To: Dee F Bruemmer, County Administrator

PLANNING & ZONING COMMISSION
STAFF REPORT
January 4, 2011

Request: Final Plat of Oak Valley Addition, a proposed eight (8) lot residential subdivision.

RESOLUTION
SCOTT COUNTY BOARD OF SUPERVISORS
March 17, 2011

Oak Valley Addition

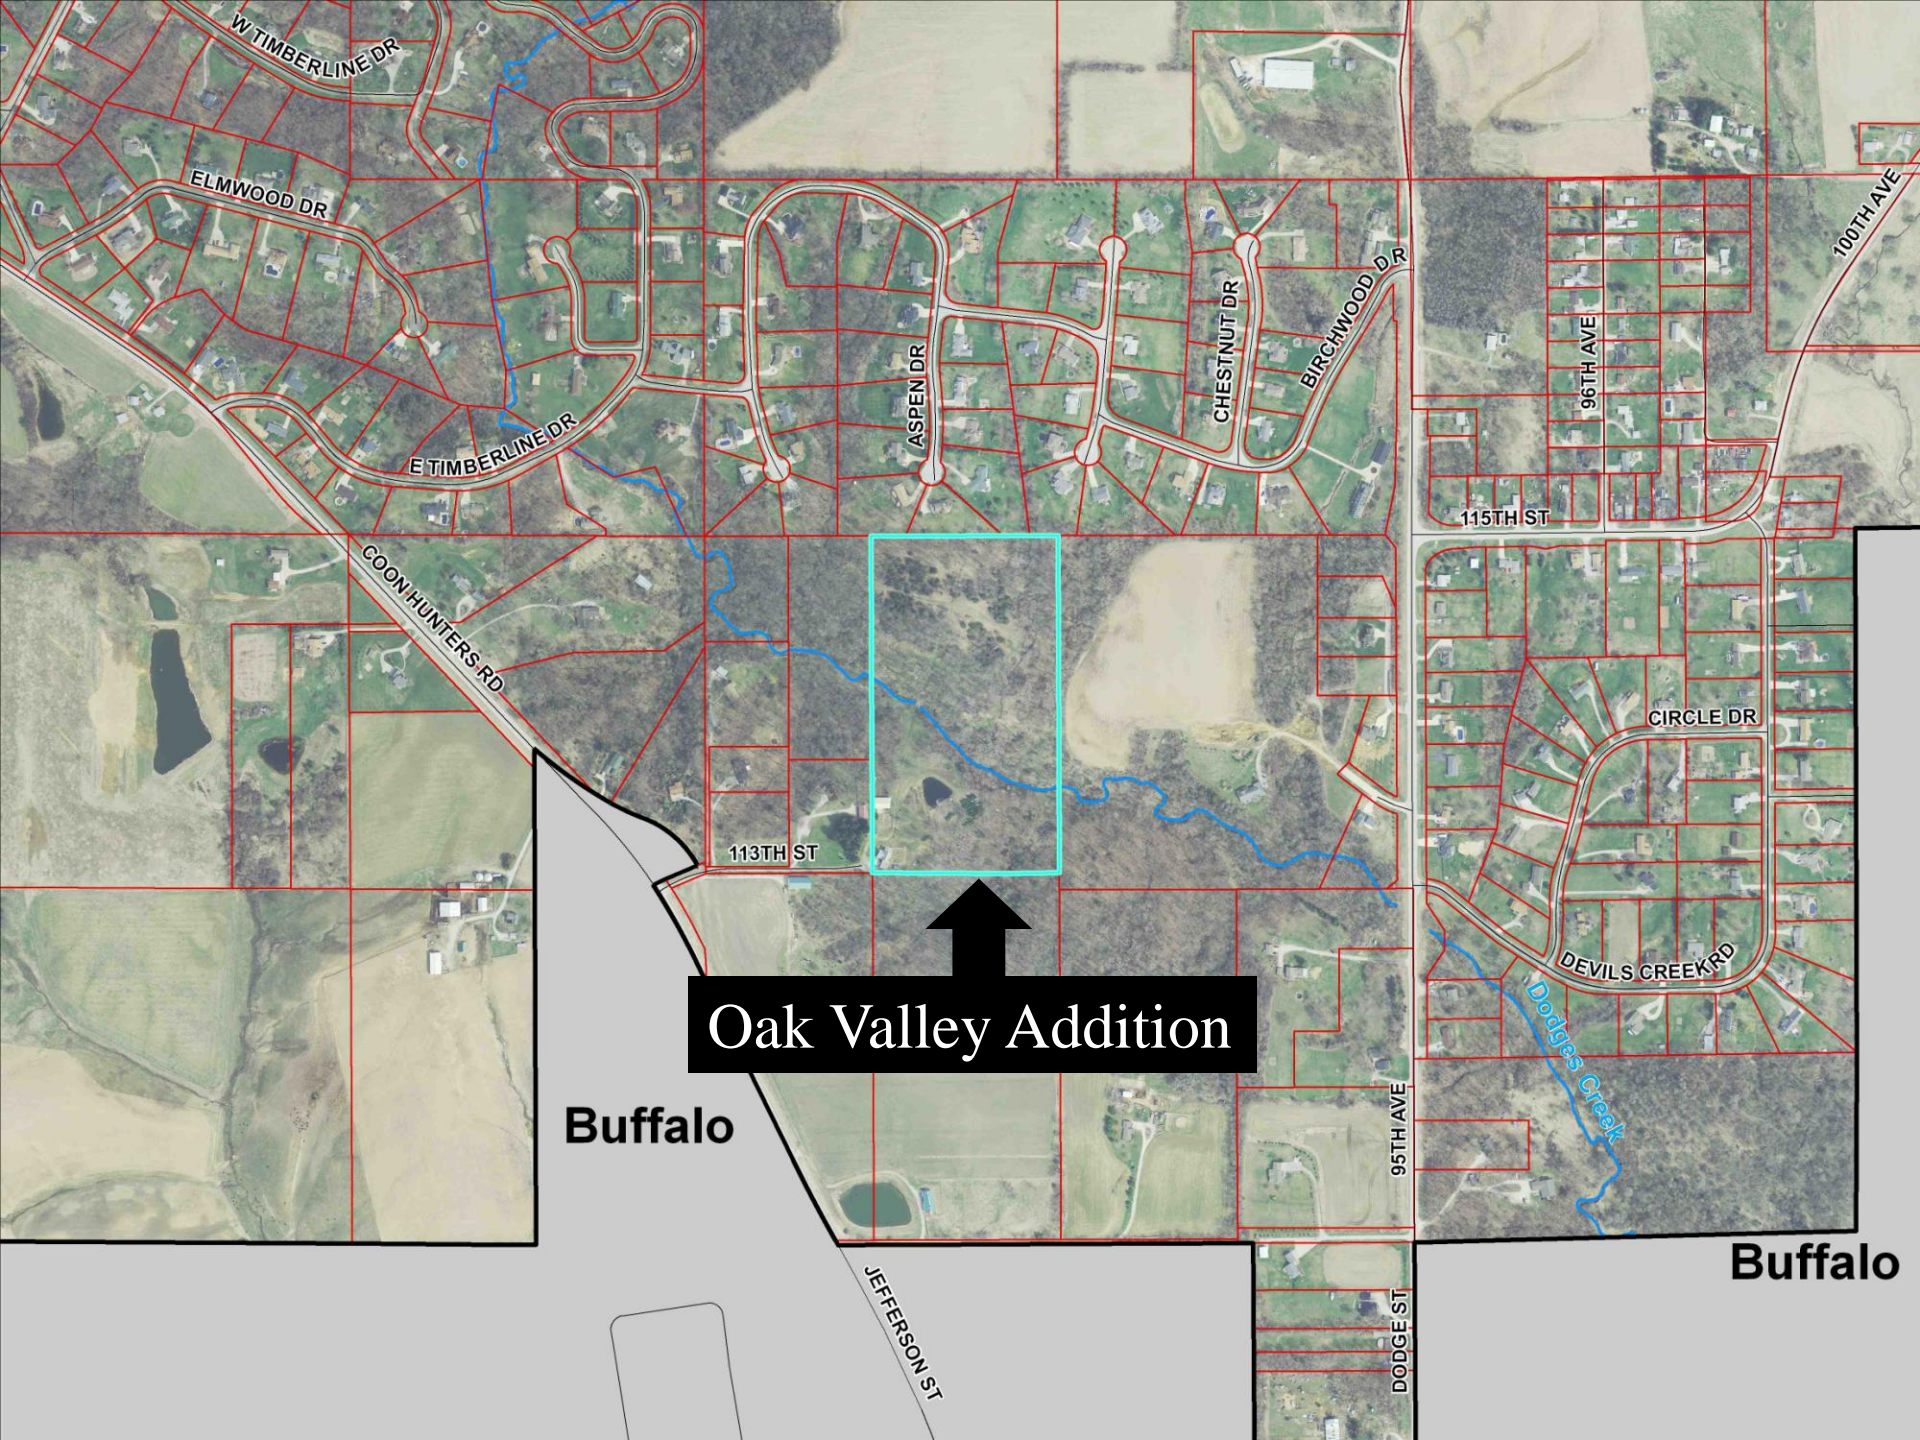
The County Engineer states that the road construction of the new road (114th Street) that extends through Kauth 2nd Addition to serve the seven lots on the north half of the property appears to have been adequately constructed. However the County Engineer does state that he has concerns that he never received, reviewed or approved any final construction plans for that road. He further states that this could definitely influence his recommendation on whether the County Board should accept these roads onto the County's system. It is also noted that no improvements have been completed to the shared access driveway (113th Street) off of Coon Hunters Road to both widen the driveway surface to 18 feet in width and pave a cul de sac bulb with a 40 foot radius. Currently the driveway is less than ten feet in width, the same it was at the time the Preliminary Plat was reviewed three years ago and there is no turnaround bulb.

RECOMMENDATION: Staff recommends that the Final Plat for Oak Valley 1st Addition be approved with the condition that surety be posted for the uncompleted road improvements to the access driveway (113th Street) prior to Final Plat approval by the Board of Supervisors.
